**TOWN OF MOUNTAIN VILLAGE
REGULAR DESIGN REVIEW BOARD MEETING AGENDA
TO BE HELD IN PERSON
THURSDAY NOVEMBER 4, 2021 10:00 AM
MOUNTAIN VILLAGE TOWN HALL
455 MOUNTAIN VILLAGE BLVD, MOUNTAIN VILLAGE, COLORADO
MOUNTAIN VILLAGE TOWN HALL**

3.	10:05	5	Haynes	Action	Approval of the DRB Schedule 2022
4.	10:10	30	Ward/ Applicant	Quasi-Judicial	Consideration of a Design Review: Final Architecture Review for a new Single Family Home on Lot 515, 134 Russell Drive, pursuant to CDC Section 17.4.11.

AGENDA ITEM 4
PLANNING & DEVELOPMENT SERVICE
PLANNING DIVISION
455 Mountain Village Blvd.
Mountain Village, CO 81435
(970) 728-1392

C3

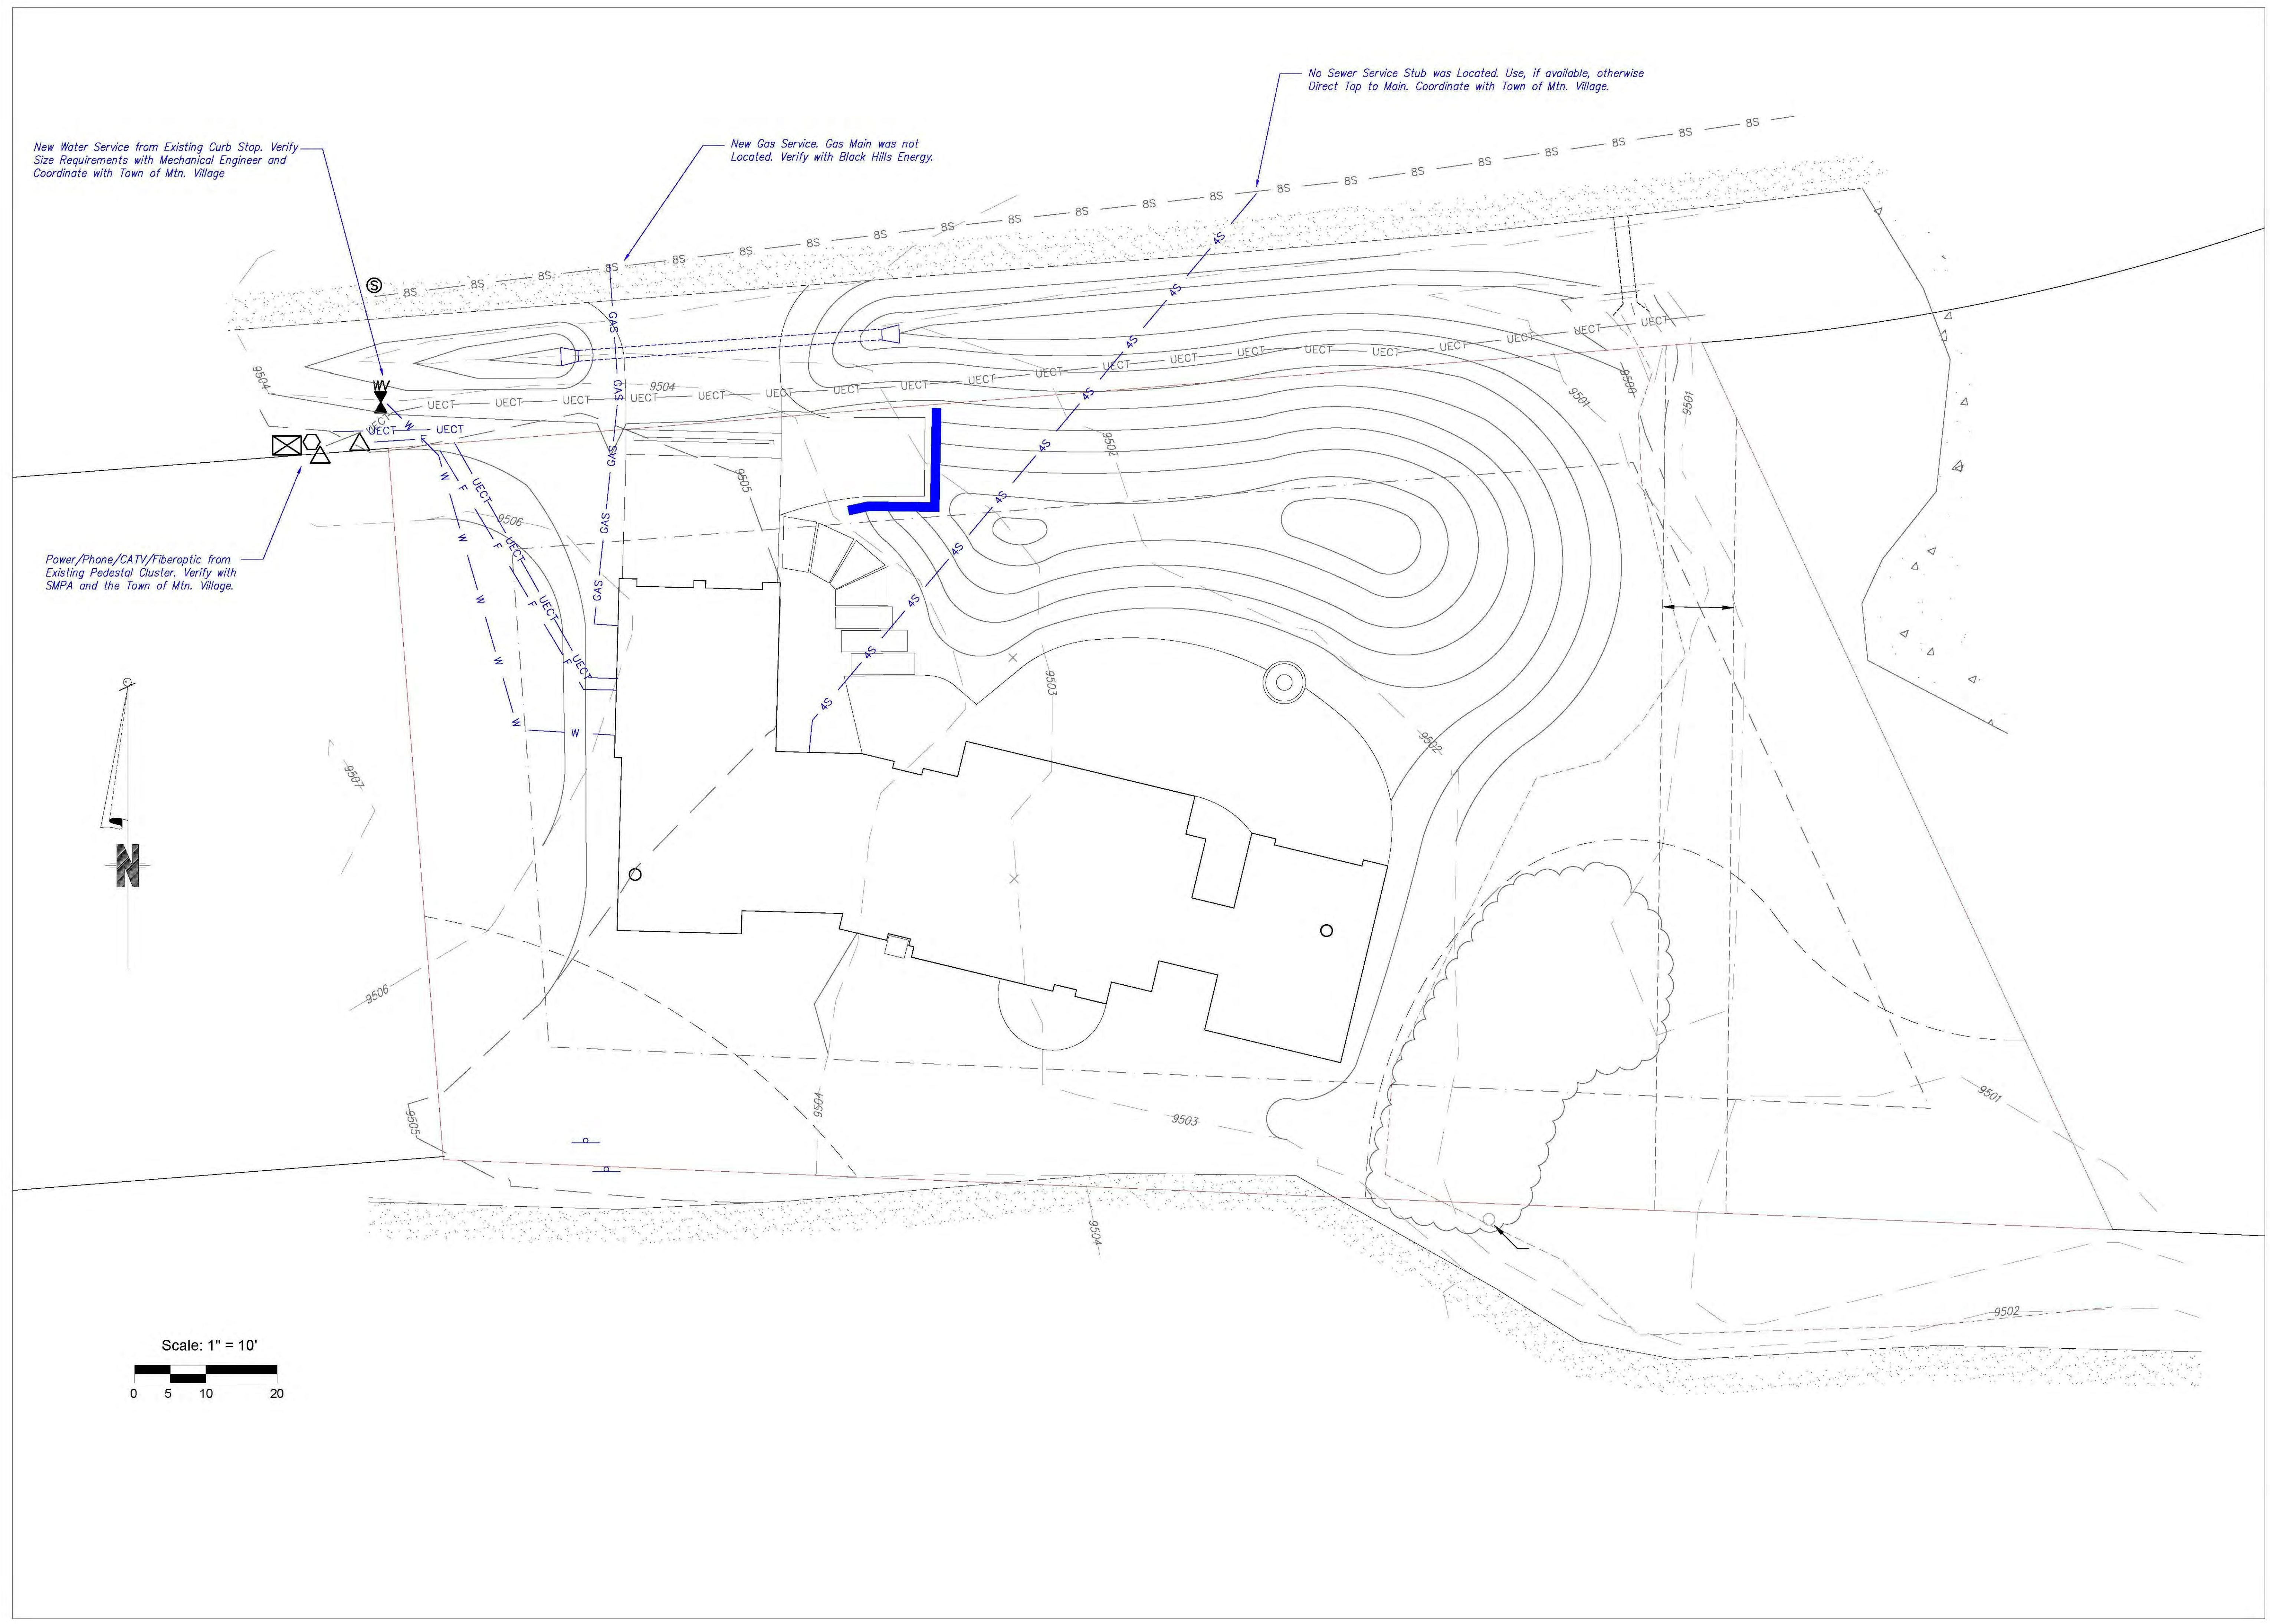
3) Prior to final review, the applicant shall revise the utilities plan to remove the encroachment from Lot 514 or provide owner authorization for the installation of utilities from the owner of Lot 514.

Staff: Existing utilities pedestals are in the road right of way near the northwest corner of the lot. The applicant has revised the utility plan to show no encroachment on Lot 314.

Please see details on Sheet C3 for the re-routing of the utilities.

C4

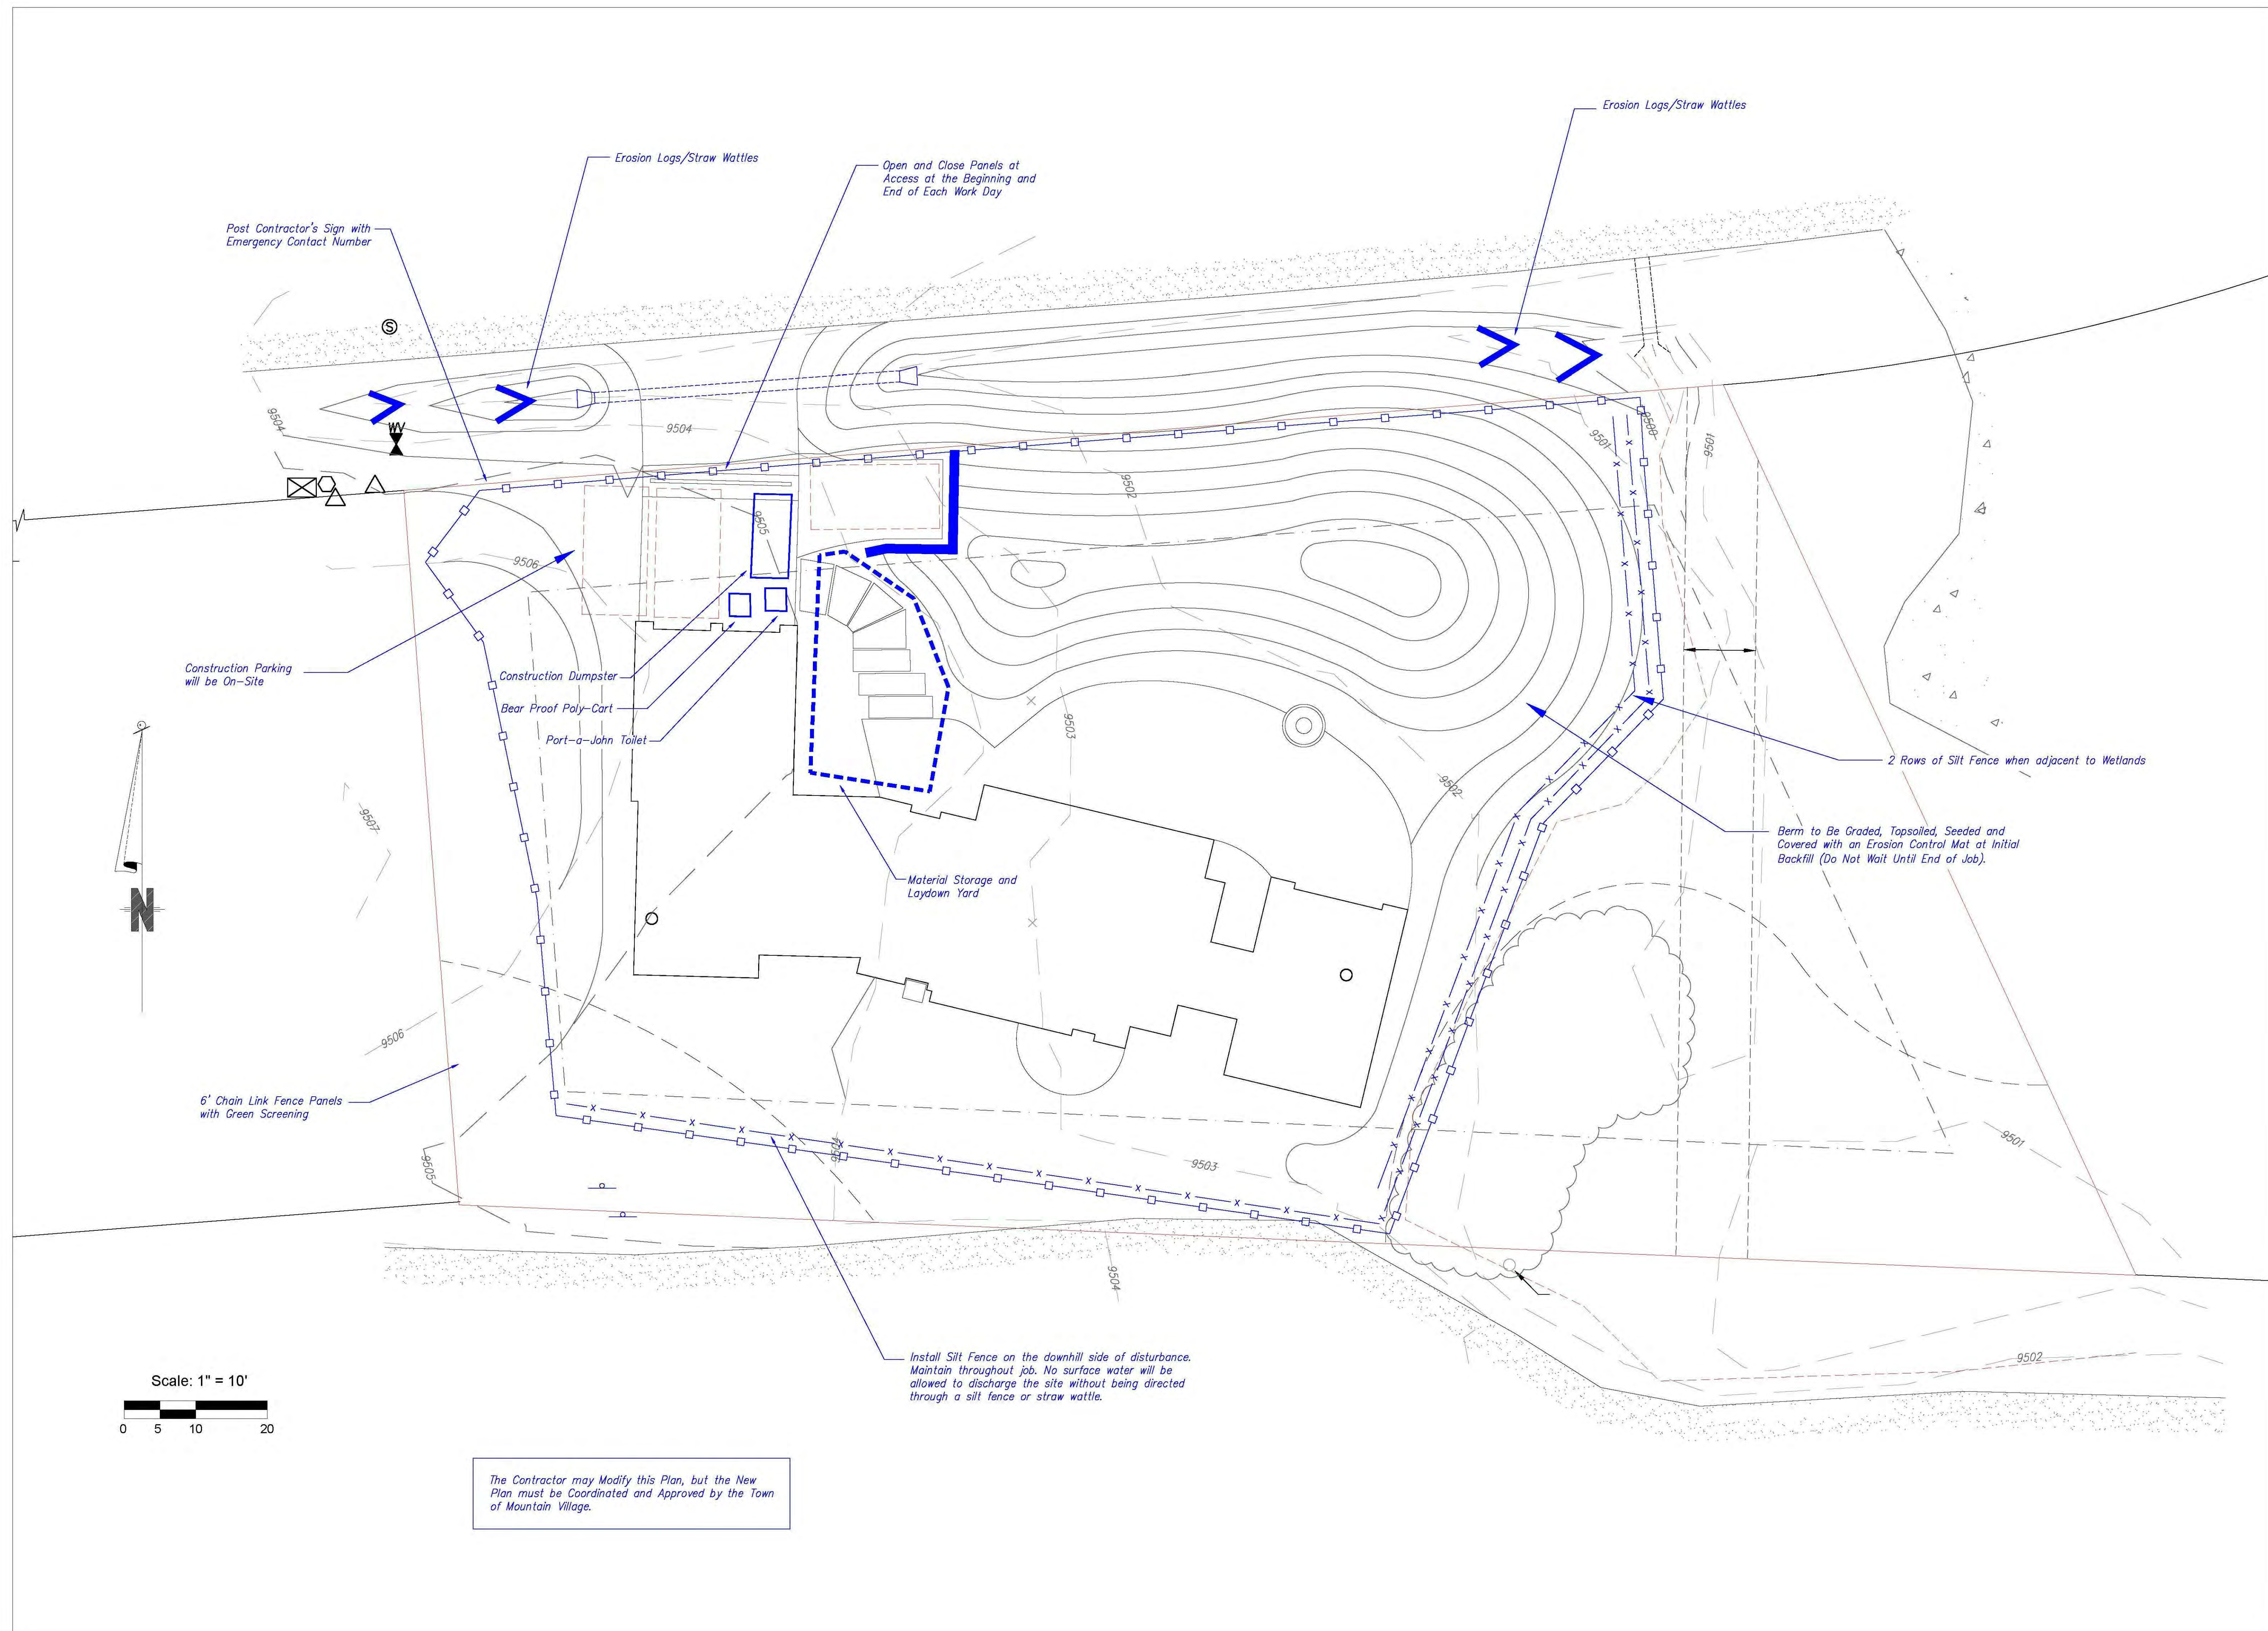
6) Prior to final review, the applicant shall revise the construction mitigation plan to bring the construction fence out of the GE wherever possible, and to add additional protections of the SE side of the proposed berm to prevent silt entering the wetlands.

Staff: The construction mitigation plan has been revised. The new plan brings the construction fencing closer to the home site, although some areas of the GE will still be disturbed, the landscaping plan does indicate that these areas are all to be revegetated with Town native seed mix. Staff concerns about the wetland area to the SE corner of the lot have been addressed by adding an additional layer of silt fencing as well as by mandating that the berm is graded, seeded and covered with erosion control mat at the time of initial backfill instead of waiting until the end of the job. This should address staff concerns about the potential for new topsoil to wash into the wetland area. The proposed parking was not changed, the contractor will still need to work with the Town to obtain permissions/permits for any road right of way parking during construction.

Please see details on Sheet C4 for additional silt protection and re-location of the construction fence.
